TOWN OF RIB MOUNTAIN

PLAN COMMISSION

OFFICIAL NOTICE & AGENDA

FROM: Steve Kunst, Community Development Director
DATE: July 17, 2018
SUBJECT: General Development and Precise Implementation Plan Review

SHEET
C-1

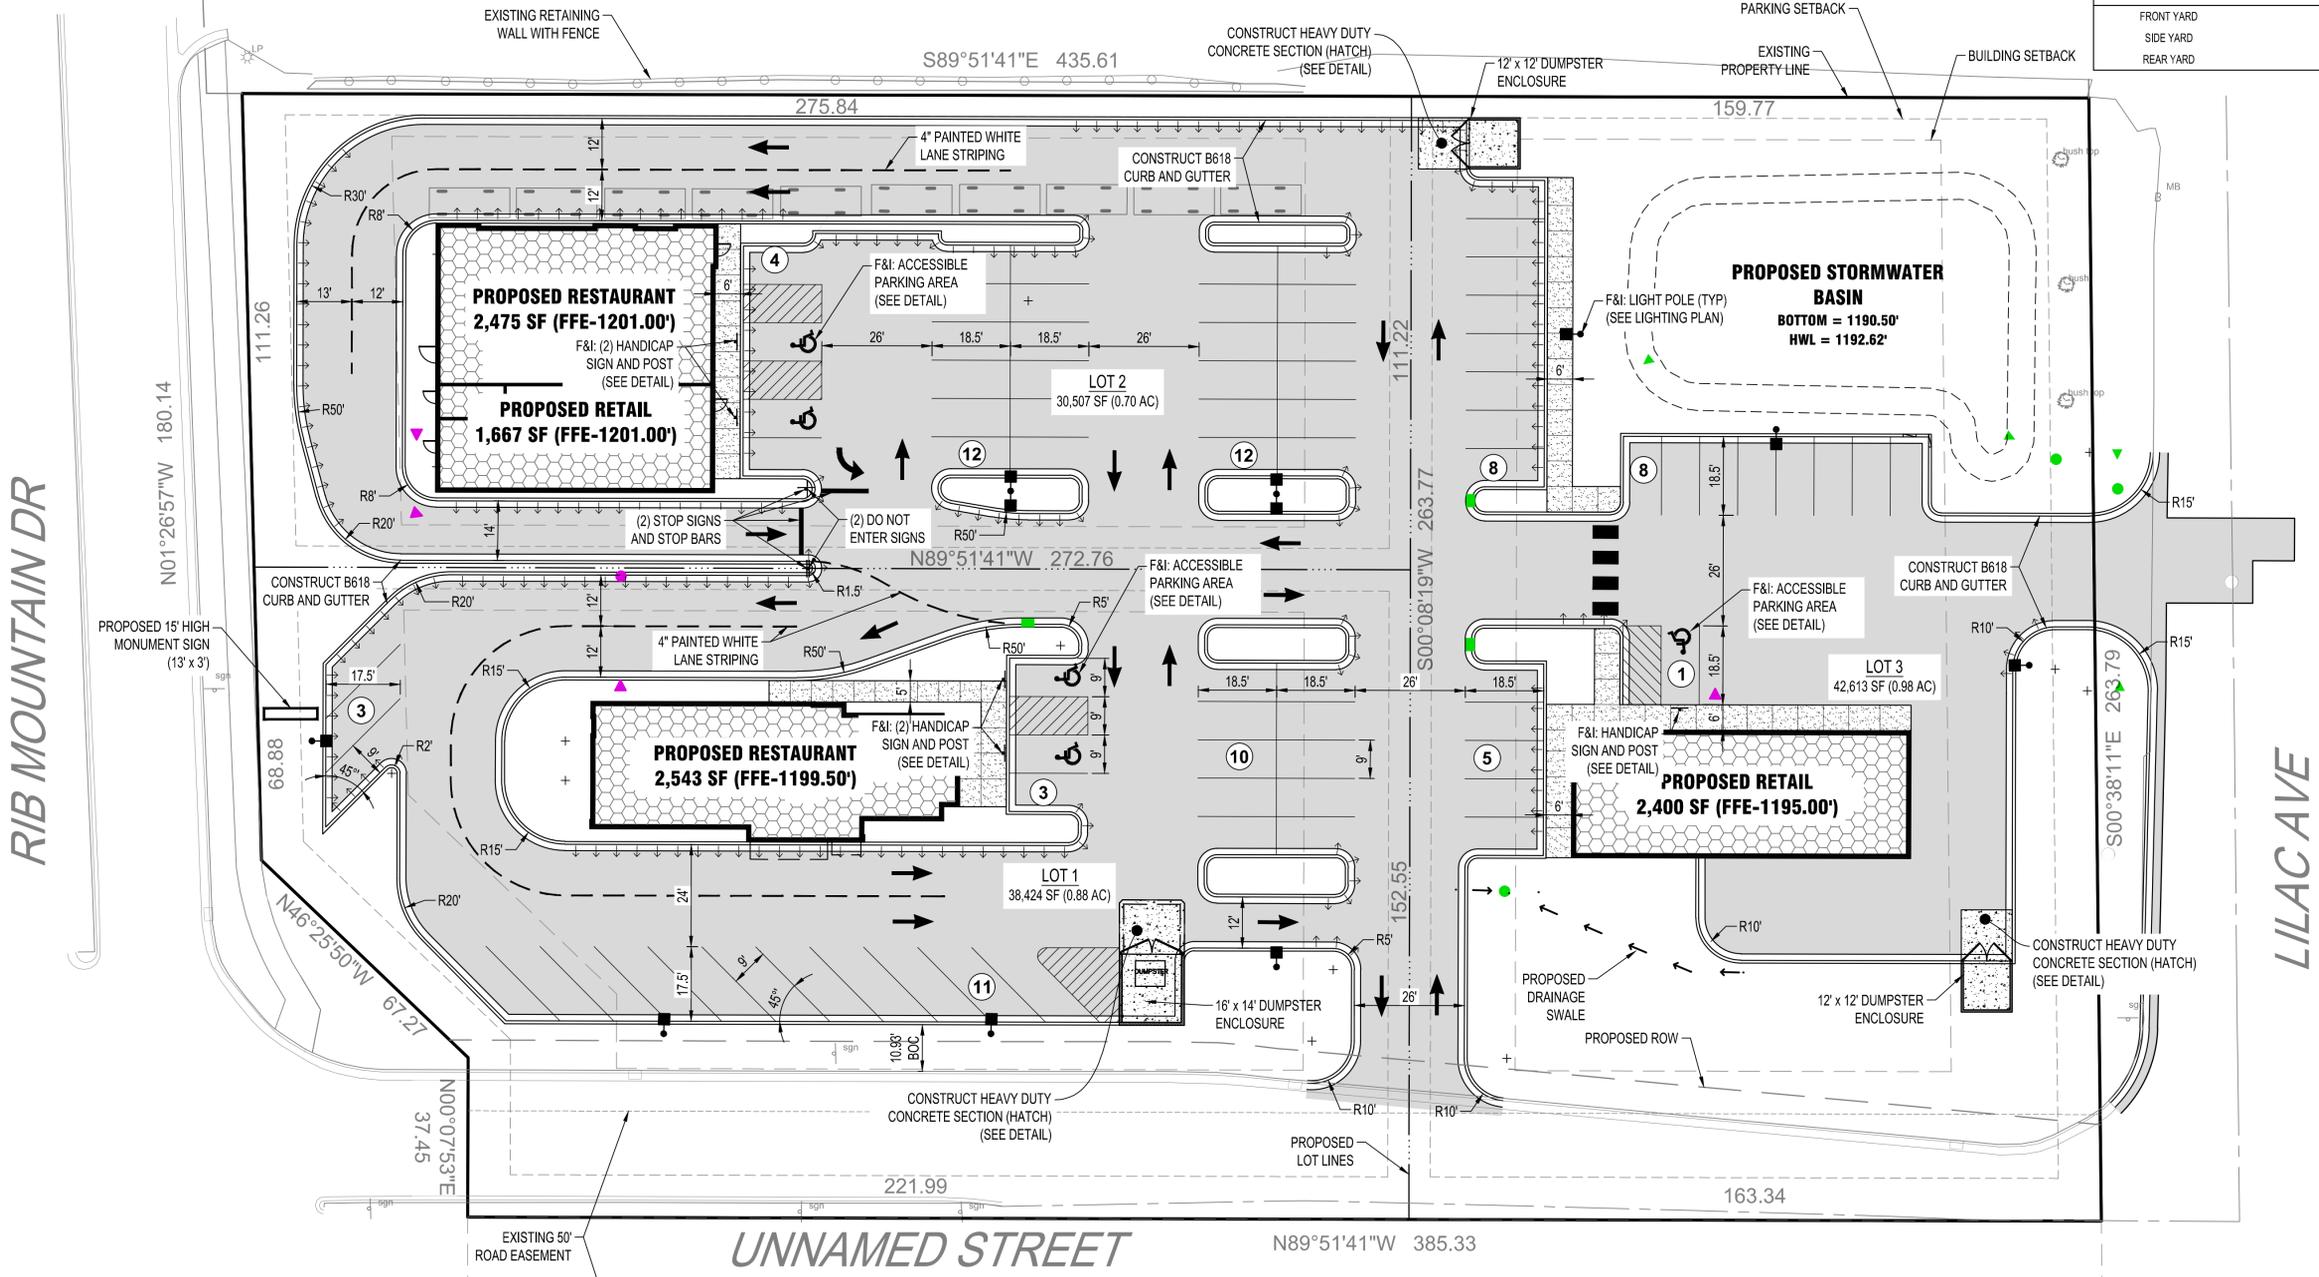
- In need of a complete sign plan.
 - Plan simply needs to include the number of signs and area calculations. Specific tenant logos are not necessary at this point.

- Consideration for shared refuse and recycling area.
 - Proposed location of dumpster enclosure on Lot 1 is not ideal, especially considering a bike/ped path immediately to the south.
- Concerns exist with proposed Lilac Ave access point from Lot 3 being too close to the intersection of Lilac Lane and the new public road to the south. Depending on redevelopment scenarios for the land to the east, a traffic signal may be necessary. Therefore, the proposed layout may not provide enough room for adequate vehicle stacking.
- Consideration for analyzing traffic generation as to its impacts on current level of service in conjunction with traffic from Kwik Trip and Ryder Truck.

- Any approval should be conditioned upon an approved stormwater management plan
 - Plan was submitted and is currently under review.
- Any approval should be conditioned upon the Town receiving a copy of a draft three party agreement for stormwater maintenance as the proposal calls for a shared facility.

SHEET
C-1

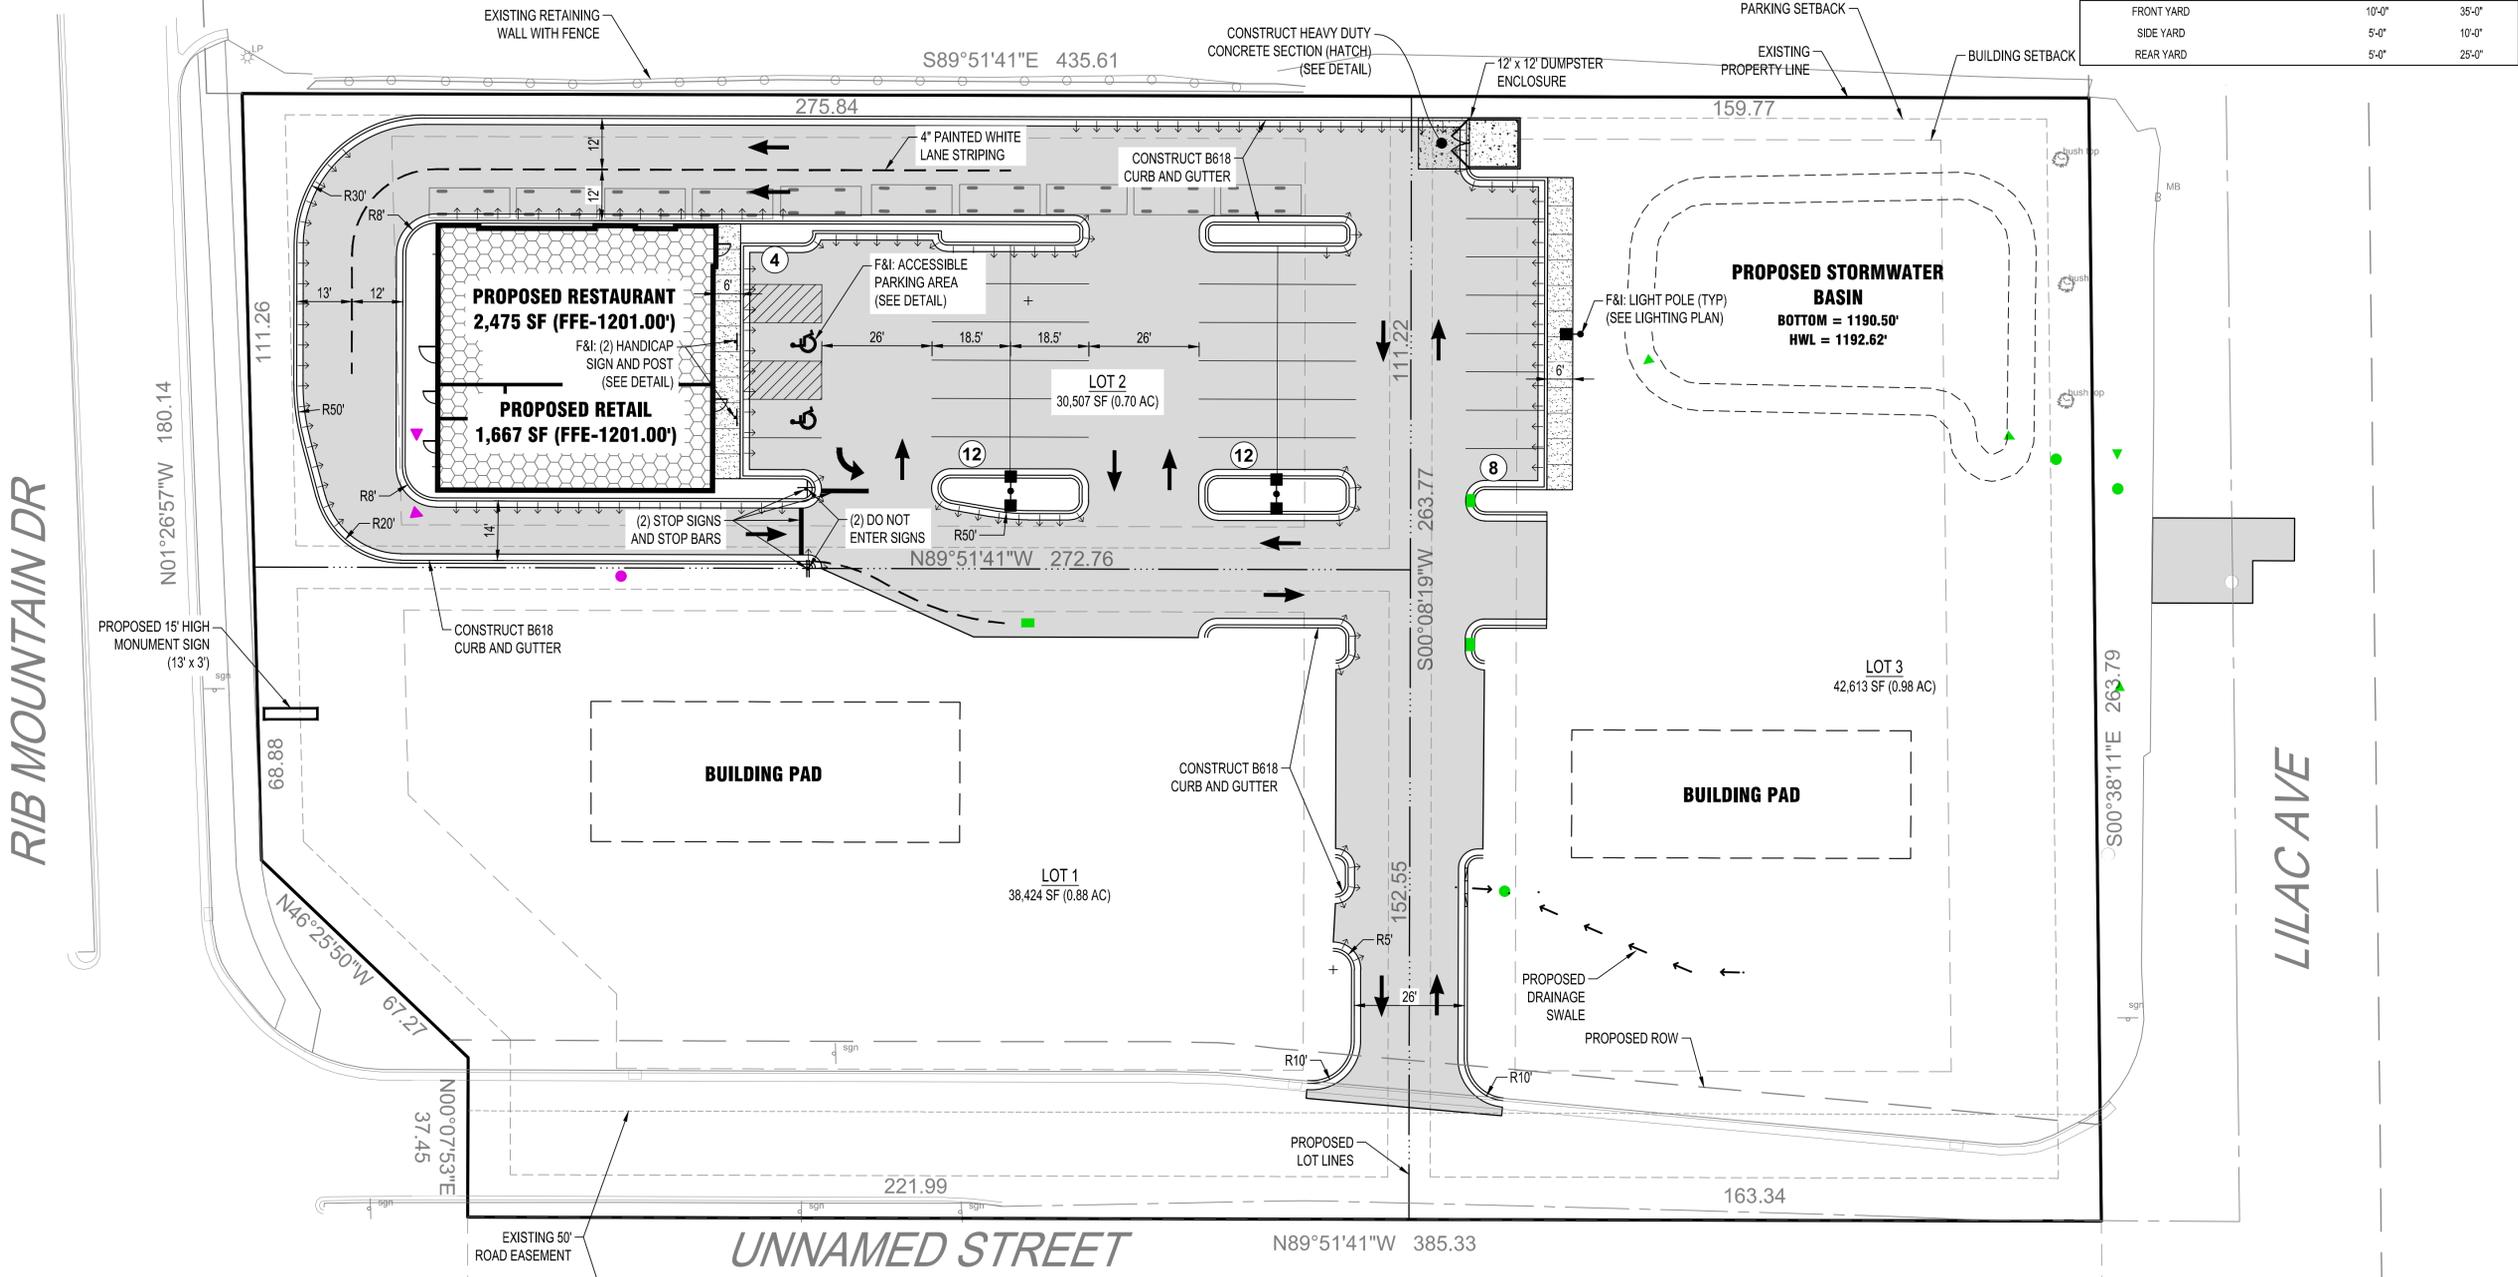
The RMMC requires listing zoning standards not being met by a proposed UDD request for the purpose of helping the Plan Commission by providing information necessary to determine the relative merits of the project in regard to the private vs. public benefits. Below is a list of the staff identified code non-compliances when compared to the traditional zoning district of Urban Commercial:
